## Resource consent application – Further information request

Application number(s): BUN6044955 / DIS60449556 / LUC604449557

Address: 395 Fitzgerald Road, Drury, Auckland

Proposed activity(s): The construction of two new warehouses and associated

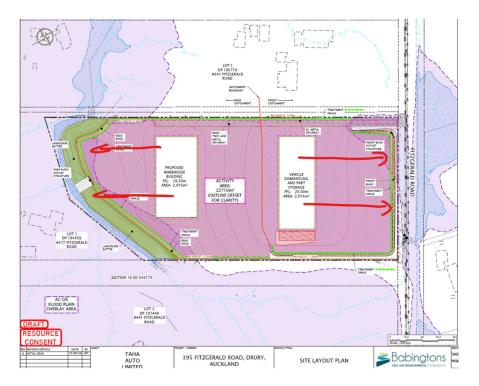
1. Please provide cross-section and long-section plans for the proposed retaining walls and areas that have been marked and shown on the below diagram for the 2yr, 5yr and 100yr event.

The cross-section plan(s) shall include the swale and the bund in relation to the buildings and property boundaries.
